Ratool Apparels Ltd. (Extension 2)

6 November 2023

1. Building Information

Observation-1: Foundation found to be stressed considering 5 storied building.

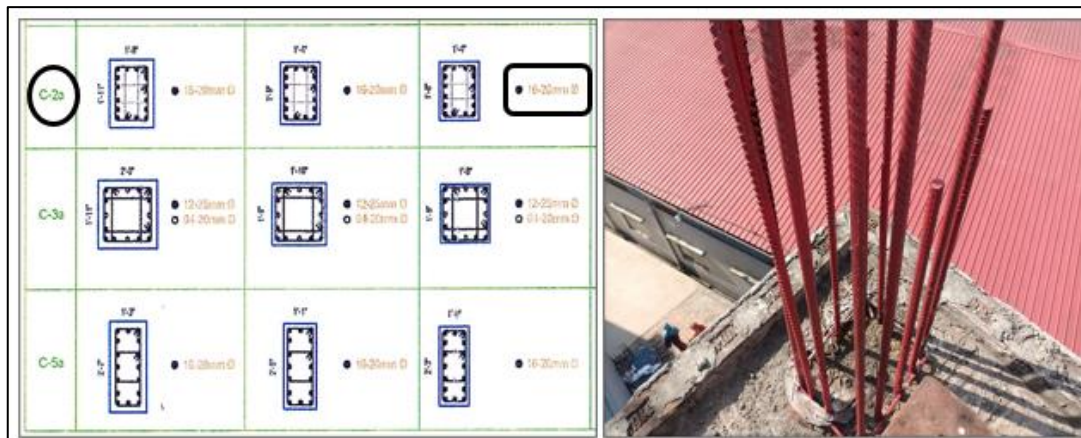
Description: Cursory calculation indicates the highlighted foundations are inadequate for both bearing & punching considering minimum concrete strength. Also, the loading is considered 4 kPa as per prepared floor load plan and allowable bearing capacity of soil is **3 tsf (FS: 2.5)** at 2.13 m depth. Building engineer is required to verify in-situ material strength as frequency of material strength test does not meet the minimum requirement and review the design load and foundation stresses.

Observation-2: Discrepancy in as-built drawing (Building-05; Main Production Building).

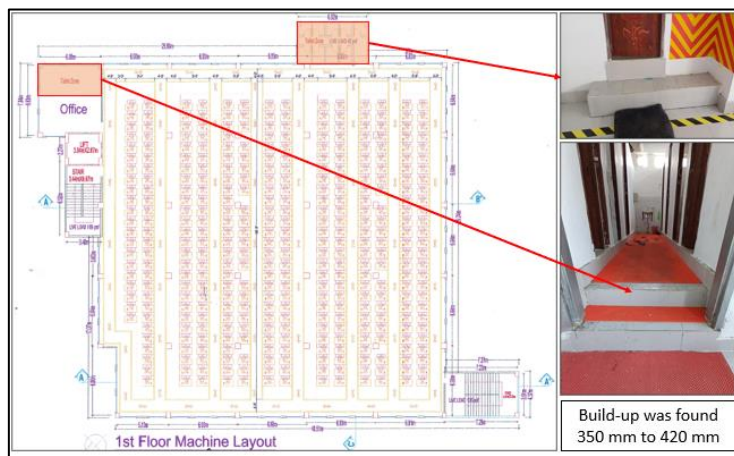
Description: During inspection, 14 rebar were found in column-2a whereas 16 rebar were mentioned in as-built drawing.
